SOLICITATION NUMBER: COR61550
Addendum Number: 1

ATTACHMENT A**COR61550****Pruntytown Correctional Center****Road Replacement Project****Questions:**

WV DOC PROJECT # COR61550
FACILITY SITE DRAWING
EXHIBIT #1 - REVISION #1

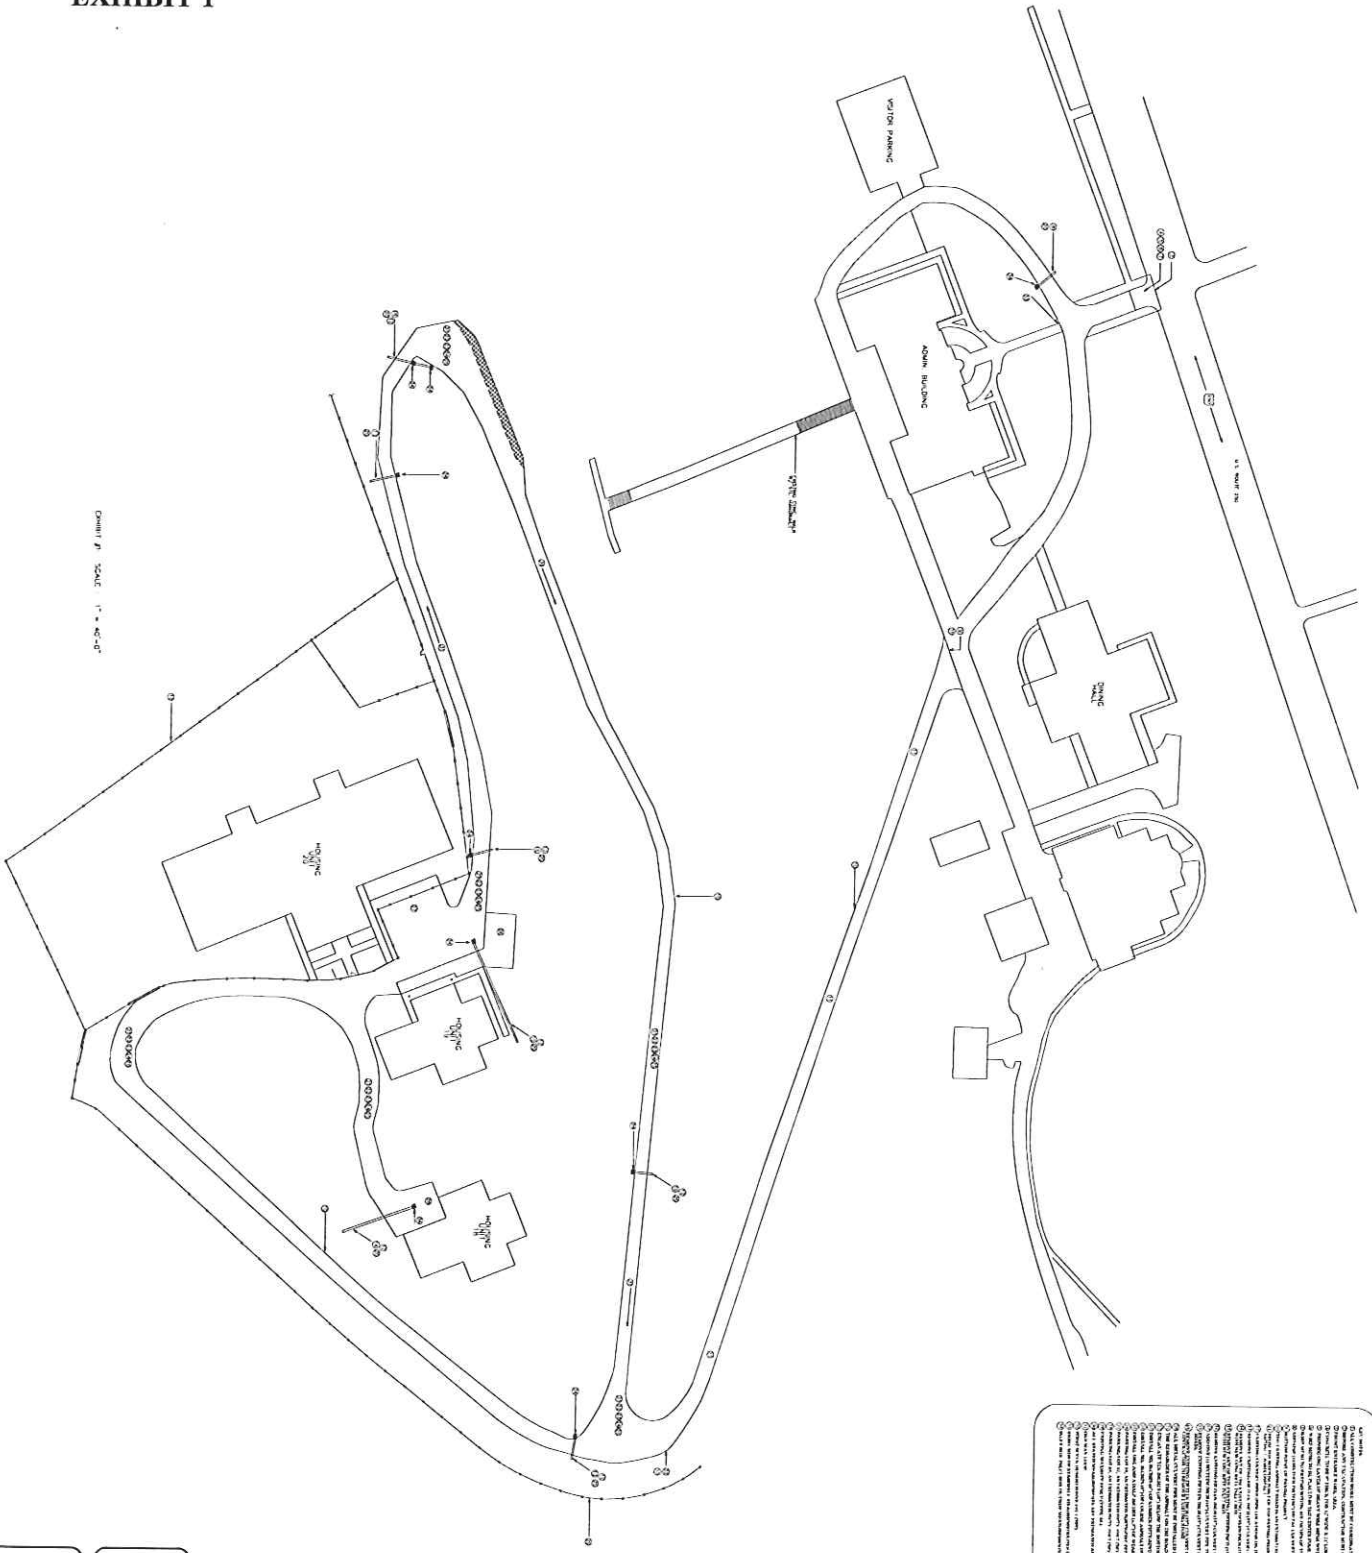
- A2: Accepted to use latex paint.
- Q3: We recommend a drop inlet in front of building #19.
- A3: Please see information in the below clarification and attached drawing.

- A8: Please see attached drawing.
- Q9: The concrete entrance detail is oversized. We feel a WVDOT entrance Type IV curb and apron 9" thick would handle the traffic into the facility.

- C1: At the entrance to Administration I Building, the concrete has been extended an additional three feet (3') onto the side of the road. Please see attached drawing to see the changes. It will be the contractor responsibility to coordinate with the Taylor County Department of Highways concerning this area.

- C3: Please see Exhibit #1 – Revision #1 for new drawing layout.
- C4: Please see Exhibit #2 for Key Notes that are on Exhibit #1 – Revision #1.
- C5: Please replace the Bid Form with the following revised bid form.

4. CONCRETE TO BE 9" THICK FOR 12' WIDE X 21' LONG AREA. THE AREA THAT EXTENDS ONTO THE ROAD IS WIDER THAN 12" AND CURVES AROUND THE SIDEWALK.
5. PROVIDE ONE LAYER OF HEAVY WIRE MESH WVDOT STANDARD.

6. WIRE MESH TO BE PLACED IN THE CENTER FOUR AND A HALF INCHES (4.5") ABOVE THE BOTTOM OF THE BOTTOM OF THE CONCRETE BOTTOM.
7. WIRE MESH TO EXTEND WITHIN SIX INCHES OF THE SIDES OF THE CONCRETE AREA.

8. ADD ONE (1) SIXTEEN INCH (16") METAL CULVERT PIPE TWENTY FEET (20') IN LENGTH AND CONCRETE INLET BOX.
9. BOTTOM POINT OF PAVING PROJECT.
10. THE EXISTING ASPHALT ROAD IS AN ESTIMATED TWELVE FEET (12') WIDE.

11. FROM THE BOTTOM POINT OF THE PAVING PROJECT TO POINT SEVEN HUNDRED FIVE FEET (705'), SPRAY TAC ON THE EXISTING ASPHALT, INSTALL 2" OF WEARING ASPHALT ON THE EXISTING ASPHALT, AND COMPACT.

13. REMOVE EXISTING FIFTEEN INCH (15") CULVERT PIPE THAT EXTENDS FORTY-TWO FEET (42') IN LENGTH. INSTALL NEW SIXTEEN (16") METAL CULVERT PIPE WITH NEW CONCRETE INLET BOX.

14. REMOVE ANY OF THE EXISTING FIFTEEN INCH (15") CULVERT PIPE THAT IS IN THE WAY. INSTALL NEW SIXTEEN (16") METAL CULVERT PIPE THAT WILL EXTEND SIXTY FEET (60') IN LENGTH WITH NEW CONCRETE INLET BOX.

15. REMOVE ANY OF THE EXISTING FIFTEEN INCH (15") CULVERT PIPE THAT IS IN THE WAY. INSTALL NEW SIXTEEN (16") METAL CULVERT PIPE THAT WILL EXTEND NINETY FEET (90') IN LENGTH WITH NEW CONCRETE INLET BOX.

16. REMOVE EXISTING FIFTEEN INCH (15") CULVERT PIPE THAT EXTENDS THIRTY FEET (30') IN LENGTH. INSTALL NEW SIXTEEN (16") METAL CULVERT PIPE WITH NEW CONCRETE INLET BOX.

17. ADD ONE (1) SIXTEEN INCH (16") CULVERT PIPE TWENTY-FIVE FEET (25') IN LENGTH AND CONCRETE INLET BOX.

18. REMOVE EXISTING FIFTEEN INCH (15") CULVERT PIPE THAT EXTENDS SEVENTY FEET (70') IN LENGTH. INSTALL NEW SIXTEEN (16") METAL CULVERT PIPE WITH TWO (2) NEW CONCRETE INLET BOXES.

19. REMOVE EXISTING FIFTEEN INCH (15") CULVERT PIPE THAT EXTENDS TWENTY FOUR FEET (24') IN LENGTH. INSTALL NEW SIXTEEN (16") METAL CULVERT PIPE WITH NEW CONCRETE INLET BOX. CONTRACTOR TO REMOVE EXISTING STONE.
